To:	Development Management	From:	Paddy O'Neill (AtkinsRéalis)
------------	------------------------	--------------	------------------------------

Planning App Ref:	
Service Ref:	Drainage
Date:	14/05/2026

Demolition of existing structures and construction of 90 homes, with areas of open space, a play area, sustainable drainage infrastructure, internal roads, paths and parking areas, landscaping and associated works, plant and infrastructure and discharge of conditions 7 (boundary with Abberd Farm), 8 (Surface Water), 9 (Surface Water), 14 (Construction Ecological Management Plan), 15 (Landscape Ecological Management Plan), 16 (Lighting), 17 (Wildlife Features) and 18 (Noise Assessment) of outline planning permission PL/2022/07893.

Land off Spitfire Road, Calne, SN11 8TE.
Easting: 400876; Northing: 171506.

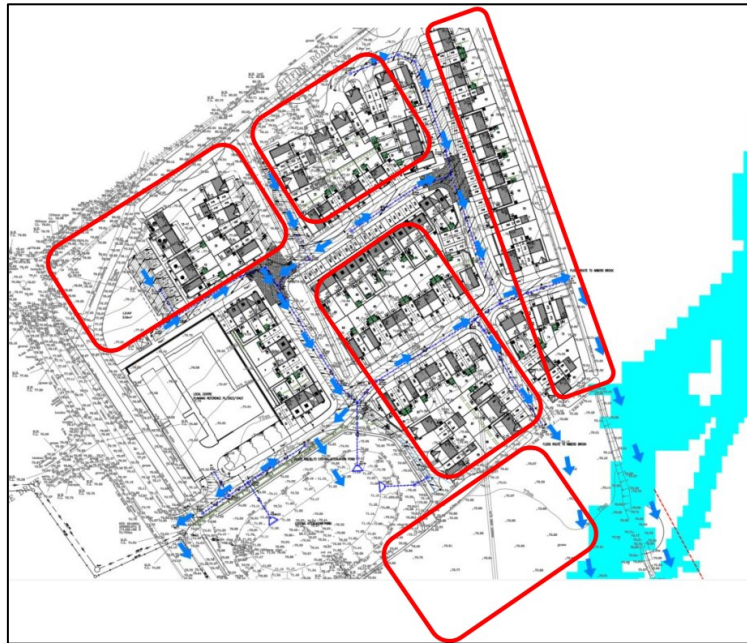
- It is noted in the Detailed Engineering – Sheet 2 that the applicant has annotated the outfall from the existing attenuation pond, stating “existing hydrobrake to be replaced with a new hydrobrake to restrict flows to new greenfield run-off rate of 62l/s, refer to section 6.3.6 of approved FRA... PL/2022/07893”.

Referring to Section 6.3.6 of the FRA dated August 2022, it is apparent the applicant proposes to restrict flows to greenfield QBAR rate.

This is not agreeable to the LLFA. The applicant must demonstrate that post development discharges provide a minimum of 20% betterment over predevelopment discharges for both peak flow and volume, for each of the 1 in 1, 30 and 100+cc rainfall events. Wiltshire Council's betterment policy can be found [here](#).

The applicant is recommended to provide a simple table of the pre-development greenfield rates, the proposed post-development discharge rate, and the betterment achieved for each rainfall event.
